# *The City of Spartanburg Design Review Board*

## **AGENDA**

**January 7<sup>th</sup>, 2025, at 5:30 P.M.  
Dr. TK Gregg Community Center  
650 Howard Street – Spartanburg, SC 29303**

1. DRB-24-020-00019 – The Design Review Board (DRB) has received a request for Preliminary Conceptual Approval for the proposed building, 189 W Main Street Development, located at 189 W Main Street (Tax Map Sheet: 7-12-20-030.00) with a zoning designation of DT-6 Zone (Downtown Urban District). **Owner: OTO Development / Agent: McMillian Pazdan Smith Architecture.**

HOTEL BALLROOM  
ELEVATION

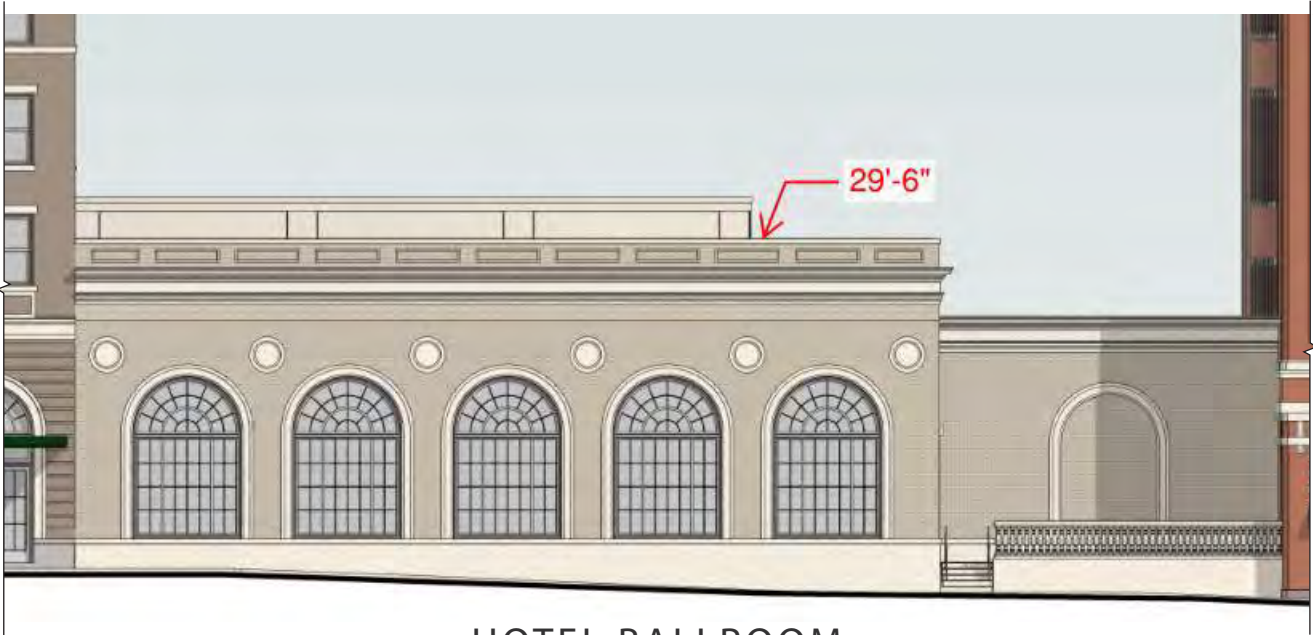
**3.3.4.a Building Height Minimum:** The proposed single-story ballroom element does provide an unusual opening in the street along a portion of Main Street that is quite wide. While it would be ideal to have a multi-story element in this area, the proposed over-height single story massing for the ballroom achieves a similar goal relative to the code standard of providing an adequate sense of enclosure for the street. The proposed height that averages in excess of 28 feet, is not too dissimilar from two-story historic facades along Main Street.

Office Building: West Elevation along S Daniel Morgan

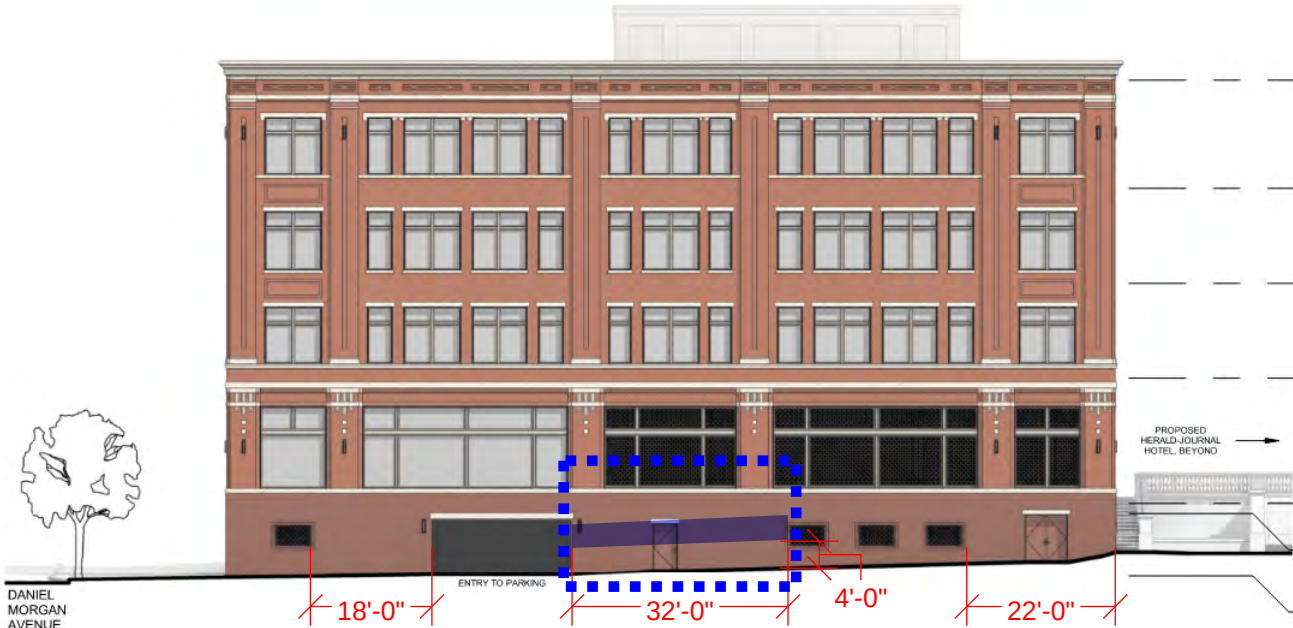
- o **6.4.4 Ground Level Detailing:** 60% Glazing in Transparency. *Please provide dimensions to the facades to be able to calculate the frontage transparency. Exception required for elevations along Daniel Morgan Avenue, Broad Street, and Spring Street.*
- o **6.4.5 Materials:** *Exception required for the use of EIFS on elevations that are visible from public streets.*

**6.4.3 Ground Level Detailing:** There are several areas along Spring Street, Daniel Morgan Avenue, and Broad Street where ground-level transparent glazing is not practical given the building functions behind it. The proposed design along Spring Street and Daniel Morgan Avenue depicts the use of art elements and decorate grates to provide pedestrian. In many ways, noting that the Spring Street frontage is not active is further support for a wider sidewalk zone.

**3 SPRING STREET STREETSCAPE PLAN**  
L1 SCALE 1"=20'

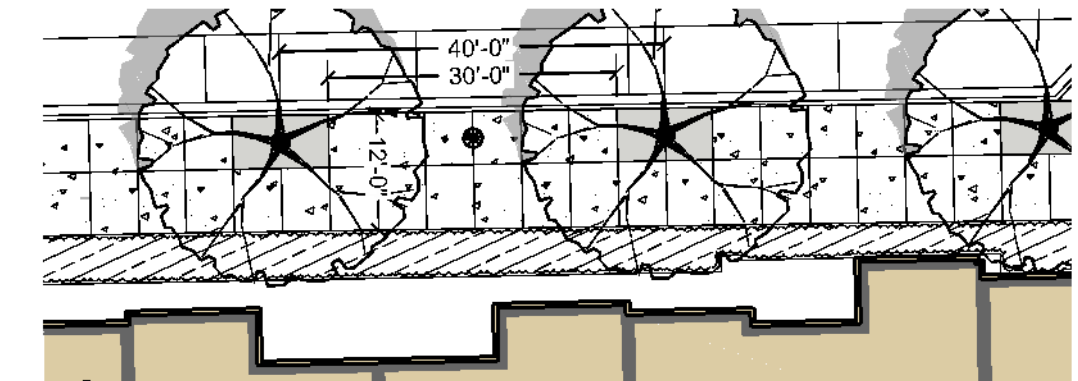
**Broad Street:** Given that this section of Broad is effectively the west end of a historically utilitarian street, we strongly recommend that a new urban design plan be developed for the entire section. The fact that the Magnolia project on the south side is facing the back side of the hotel and office building should presents an opportunity for to take a more comprehensive look at landscaping along the southern edge of the 189 West Main Street project and consider an arrival sequence that is appropriate for the mix of uses within that block.

Potential considerations include addressing the current lanes which are overly wide (15 feet X 2). The curb line is already being proposed for amendment with on-street parking, so further adjustments to the drainage and curb line could be made to narrow the street section, provide for safe pedestrian crossings, add to the sidewalk width on both sides.
